**A66 Northern Trans-Pennine project
TR010062**

**8.1 Change Application –
Application Report**

24 March 2023

Planning Inspectorate Scheme Reference	TR010062
Application Document Reference	8.1
Author:	A66 Northern Trans-Pennine project, Project Team, National Highways

Figure DC-30(e) Extract from Works Plan (After)

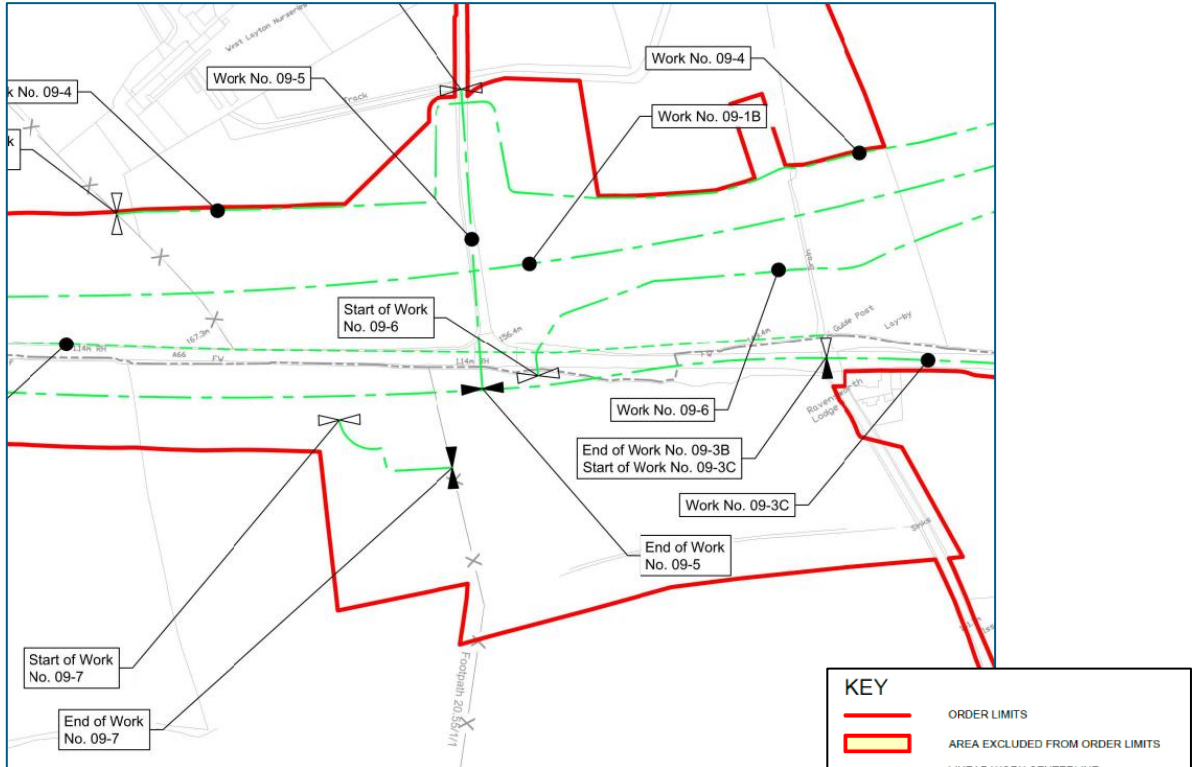
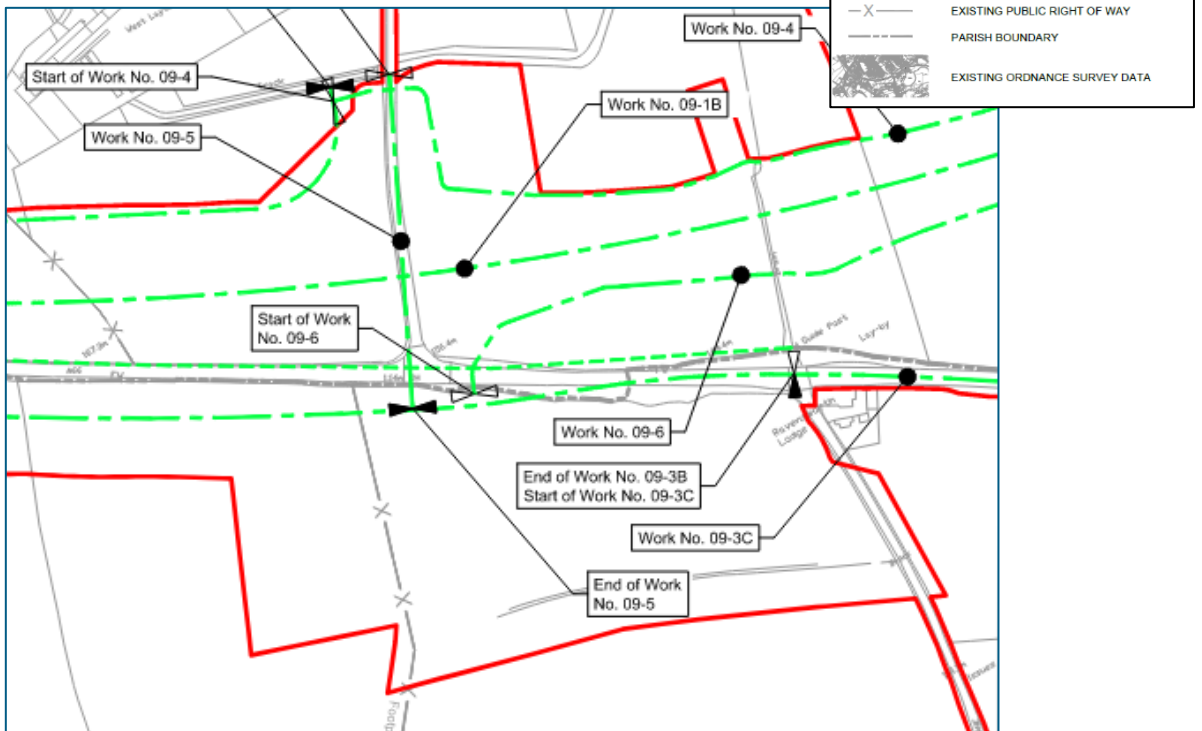
- 3.30.12. **LODs:** There are no new non-standard Limits of Deviation associated with the change or changes to the current Limits of Deviation.
- 3.30.13. Work No. 09-7, as shown in Figure DC-30(d), would no longer be required as a result of this change, as shown in Figure DC-30(e).

Figure DC-03(f) – plan showing the additional land (shaded pink) required for DC-03

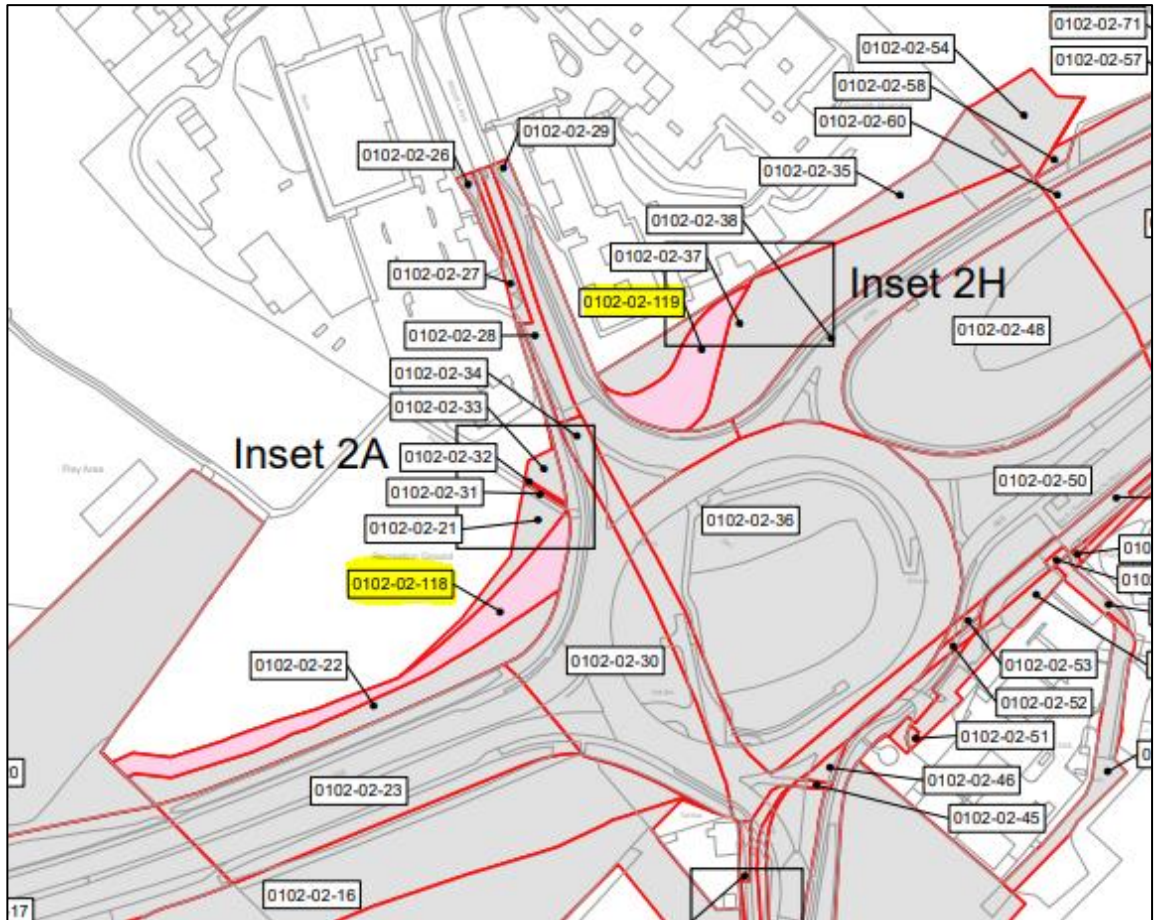
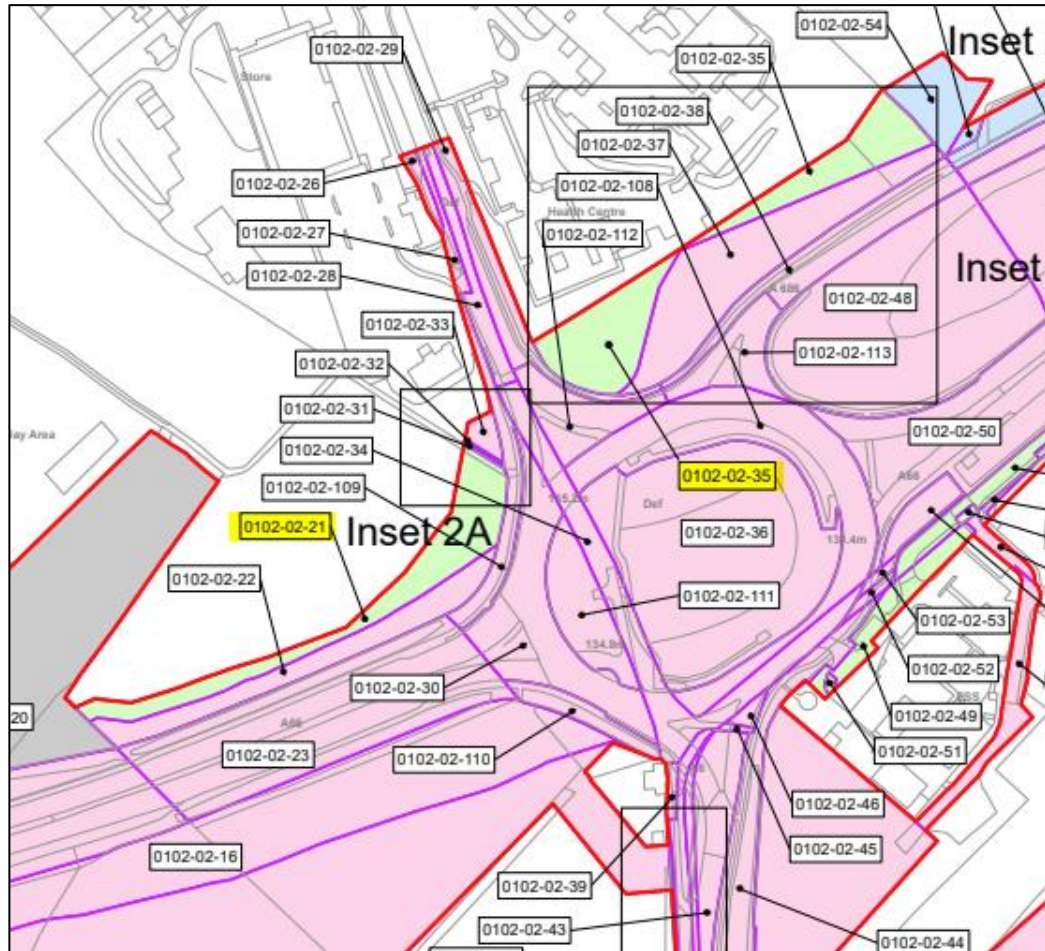
- 6.3.1. As explained in section 3.3 above, the proposal to re-orientate the Kemplay Bank roundabout within Scheme 0102 would require additional land. Land which was previously proposed to be subject to powers of temporary possession (within plot 0102-02-21 and part of plot 0102-02-35) is now required to be acquired and used permanently to accommodate the re-orientated roundabout. The new plots of pink land, identified as plots 0102-02-118 and 0102-02-119, are shown in the plot plan excerpt below (Figure DC-03(f)):

Figure DC-21(g) – showing the extended area of plot 06-02-10 (the westernmost end is additional land) and the reduced area of plot 06-02-13

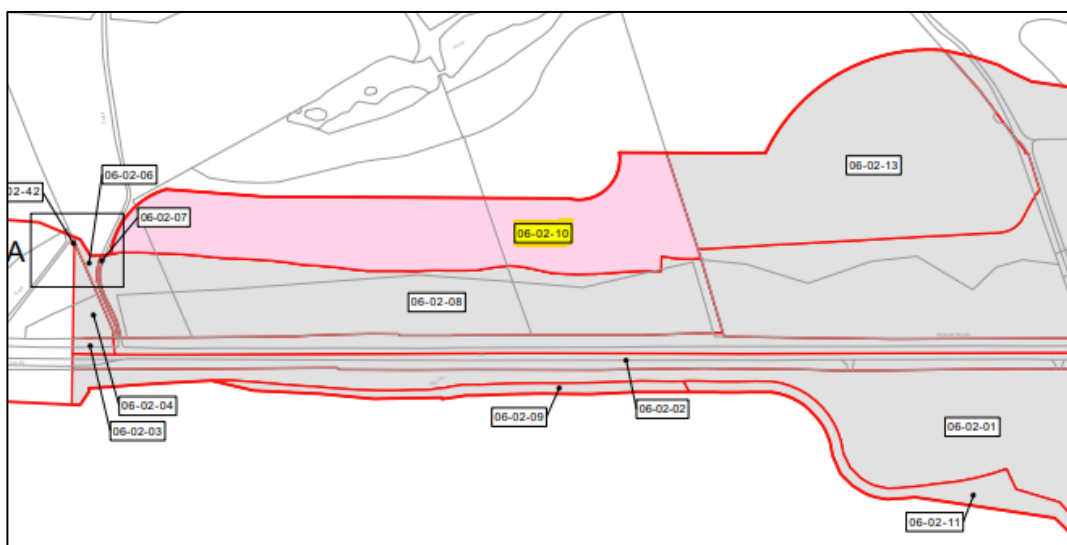
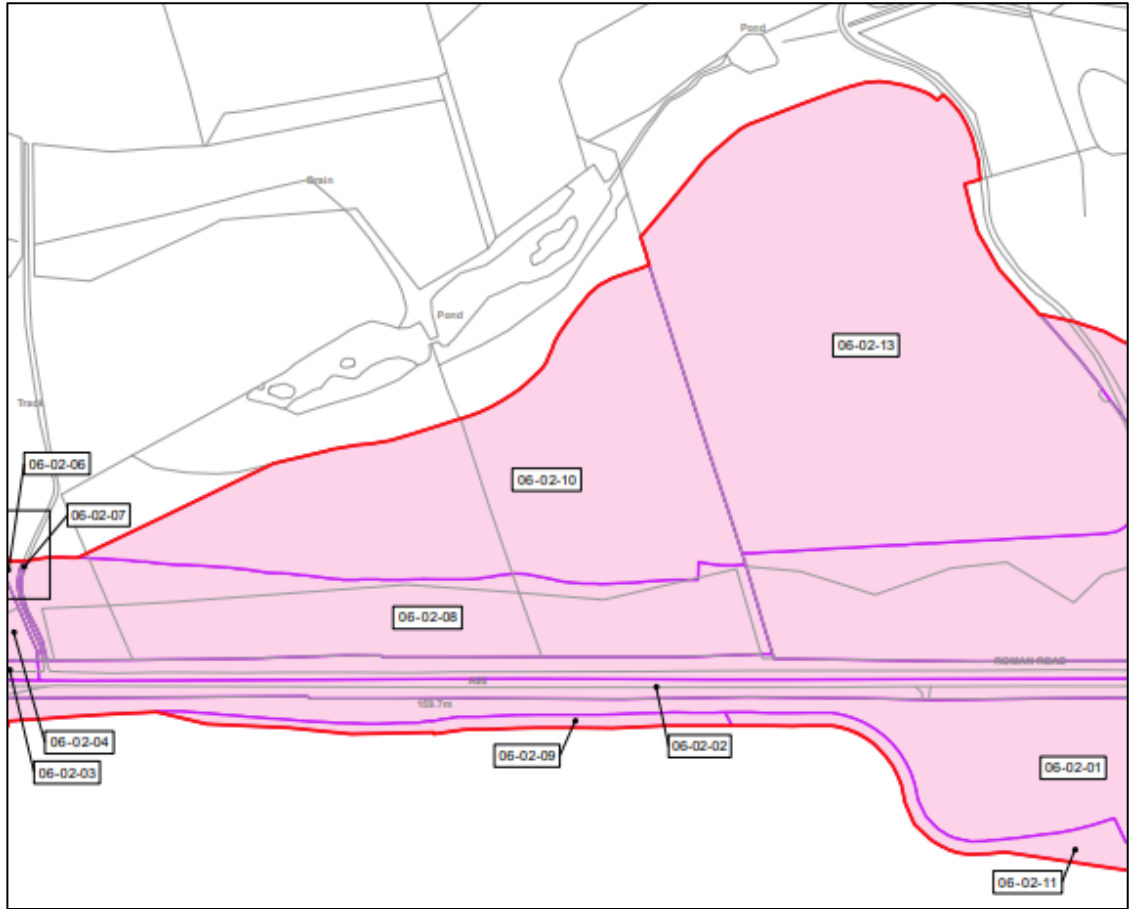
- 6.5.7. **AREA 1:** Figure DC-21(g) below shows that existing plot 06-02-10 would be extended (increasing in area) to include its westernmost extent, whilst plot 06-02-13 would be reduced in area due to the removal of its northernmost extents:

6.5.8. For comparison purposes, the corresponding excerpt from the current Land Plans [APP-307] is shown below in Figure DC-21(g):

Figure DC-27(b) – showing additional land required for DC-27

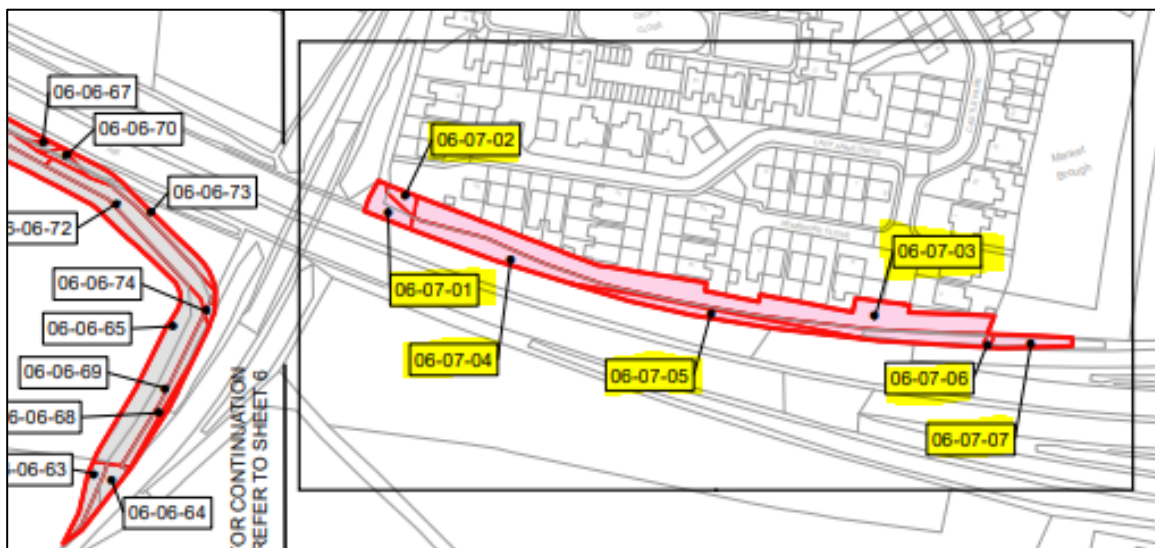
6.6.2. Additional land is therefore required, as shown in Figure DC-27(b) below:
